Serial: NPD-NRC-2008-049  
December 9, 2008

**SHEARON HARRIS NUCLEAR POWER PLANT, UNITS 2 AND 3  
DOCKET NOS. 52-022 AND 52-023  
RESPONSE TO REQUEST FOR ADDITIONAL INFORMATION LETTER NO. 018 RELATED TO  
VIBRATORY GROUND MOTION**

**Shearon Harris Nuclear Power Plant Units 2 and 3  
Response to NRC Request for Additional Information Letter No. 018 Related to SRP  
Section 02.05.02 for the Combined License Application,  
dated September 25, 2008**

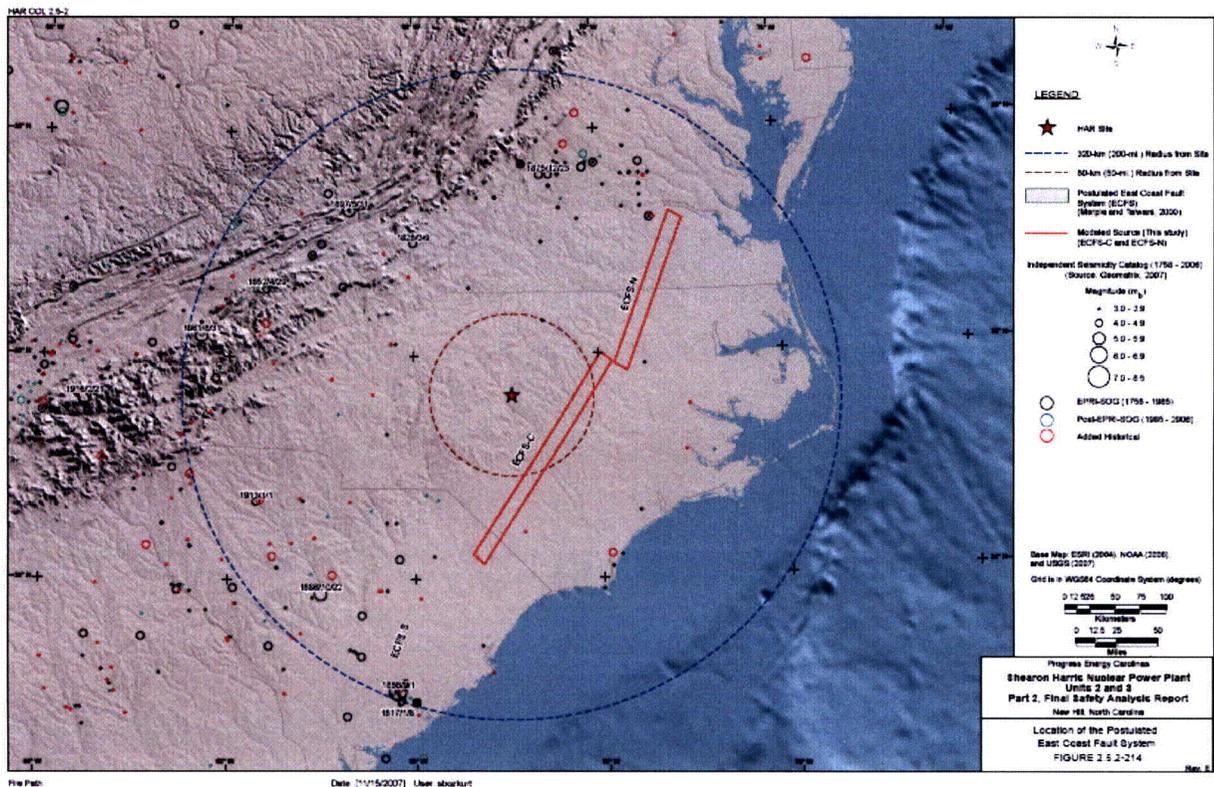
- Section 2.5.2.1.1 states that the Appendix (2AA) lists 225 earthquakes that are within 325 km of the HAR site. Appendix 2AA actually lists 1329 events covering the entire CEUS regions.
- Section 2.5.2.4.1.2 states that updated estimates of the occurrence rates for these earthquakes based on paleoliquefaction data are described in Subsection 2.5.2.4.1.1.1. The information is actually located in Section 2.5.1.1.4.3
- The April 29, 1852, earthquake was felt at Buckingham and Wytheville, Virginia, not in S. Carolina as indicated in FSAR.
- Postulated East Coast Fault System (green outlined area according to figure caption) cannot be seen on Figure 2.5.2-214.

1. Replace FSAR Appendix 2AA in its entirety (see Attachments/Enclosures).
2. Revise second paragraph of FSAR Section 2.5.2.4.1.1.1 from:

“SNC characterizes the occurrence of the repeated large earthquakes at Charleston by a characteristic earthquake model with the size and frequency of the characteristic earthquake defined by the parameters in the logic tree shown on Figure 2.5.2-213 (Reference 2.5.2-230).”

To read:

“SNC characterizes the occurrence of the repeated large earthquakes at Charleston by a characteristic earthquake model with the size and frequency of the characteristic earthquake defined by the parameters in the logic tree shown on Figure 2.5.2-213 (Reference 2.5.2-230). Two estimates of the frequency of the repeated large earthquakes were provided, one based on the number of earthquakes identified from paleoliquefaction data for the past 2,000 years and one based on the number of earthquakes identified from paleoliquefaction data for the past 5,000 years, with relative weights of 0.8 and 0.2, respectively (Figure 2.5.2-213).”
